Access Compliance Report

Public Rights-of-Way

Intersection ID: 12052	Main Street: E_17TH_ST	Cross Street: PEGRAM_ST	Location: E
ADA ID: EA2A0630B2CC	Ramp Type: BlendTrans1	Initial Pass/Fail: Fail	Overall Compliance: No
		Severity Score: 8.75	
Codes/Mitigation Info/Possible Solution		Field Measurements/Component Compliance

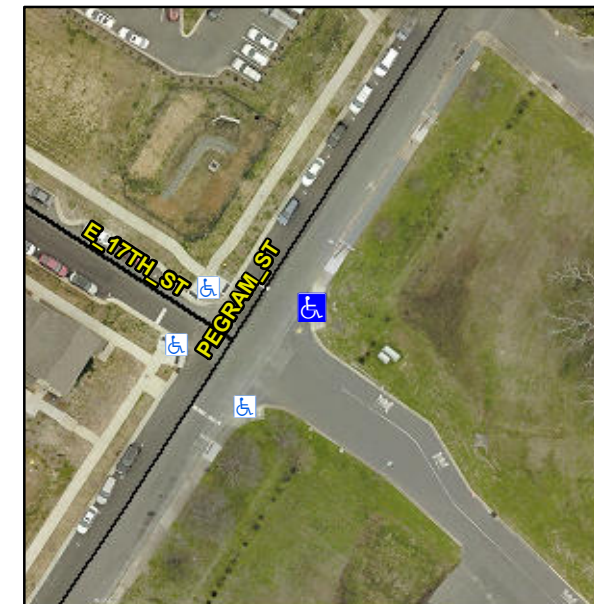
DAMAGED CURB

PROW/ADA:

R304.5.1

Remove & Replace Curb Ramp With Two New Directional Ramps or Equivalent.
